A MASTER PLANNED RESIDENTIAL COMMUNITY MASTER DEVELOPMENT PLAN

City of San Antonio, Texas

Department of Development Services

Re: Silverado Hills II Master Development Plan M.D.P. # 019-06

TYPICAL 70' R.O.W. STREET SECTION

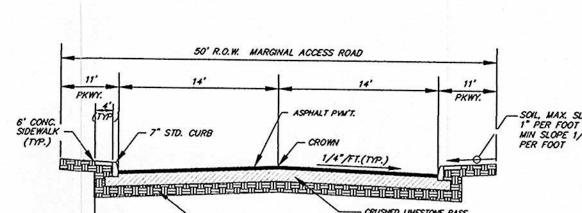
- Traffic controls shall be warranted as per the Texas Manual on Unified Control Devices and approved by Bexar County.
- The collector roadway within this subdivision will require a minimum of 44 feet of pavement marked with four lanes. Therefore, off street bike paths or additional pavement for bike lanes may be required.
